Access Compliance Report

Public Rights-of-Way

Intersection ID: 47977	Main Street: AVALY_LN	Cross Street: SPRINGS_MILL_RD	Location: SW
ADA ID: B52542E52158	Ramp Type: BlendTrans1	Initial Pass/Fail: Fail	Overall Compliance: No
Severity Score: 8.75			
Codes/Mitigation Info/Possible Solution		Field Measurements/Component Compliance

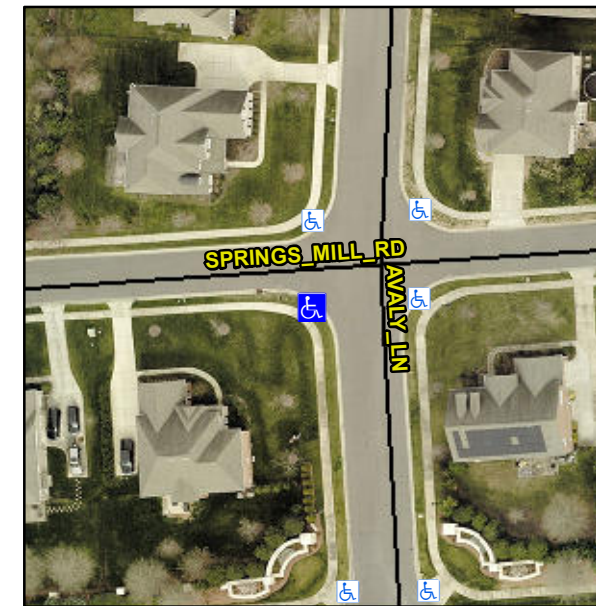
Not Found, R304.5.1

Compliance	Description	Data	Compliance	Description	Data
N/A	Ramp Length (in)	78.0	Yes	BlendTrans Slope (%)	4.1
No	Ramp Width (in)	44.0	Yes	BlendTrans XSlope (%)	2.0
N/A	Flare Type LT	N/A	N/A	Flare Type RT	N/A
N/A	Flare Slope LT (%)	N/A	N/A	Flare Slope RT (%)	N/A
N/A	Flare Traversable LT?	N/A	N/A	Flare Traversable RT?	N/A
N/A	Landing Length (in)	N/A	N/A	DWS Provided?	N/A
N/A	Landing Width (in)	N/A	N/A	DWS Contrast?	N/A
N/A	Landing Slope (%)	N/A	N/A	DWS Length (in)	N/A
N/A	Landing X Slope (%)	N/A	N/A	DWS Full Width?	N/A
N/A	Landing Curb? (Y/N)	N/A	N/A	DWS Offset (in)	N/A
N/A	Shared Landing?	N/A			
N/A	Gutter Ponding?	N/A	N/A	Gutter Slope (%)	N/A
N/A	Gutter Lip Ht (in)	N/A	N/A	Gutter X Slope (%)	N/A
N/A	Painted X Walk1?	No	N/A	Painted X Walk2?	No
	X Walk 1 Direction	To E		X Walk 2 Direction	To N
	X Walk 1 Width (in)	N/A		X Walk 2 Width (in)	N/A
	X Walk 1 Slope (%)	2.7		X Walk 2 Slope (%)	0.9
	X Walk 1 X Slope (%)	0.4		X Walk 2 X Slope (%)	3.4

N/A	Ramp inside XWalk1?	N/A	N/A	Ramp inside XWalk2?	N/A
	Road Slope (%)	3.1		Clear Space?	N/A
	Road X Slope (%)	2.7	N/A	Clear Space to XWalk (in)	N/A
N/A	Any Obstructions?	N/A	N/A	Storm Grate/Utility Hazard?	N/A
	Obstruction Type			Storm Grate/Utility Type	
		N/A			N/A
			Yes	Surface Condition? (G/P)	Good
			No	Curb Slope (%)	7.9

Remove & Replace Curb Ramp With Two New Directional Ramps or Equivalent.
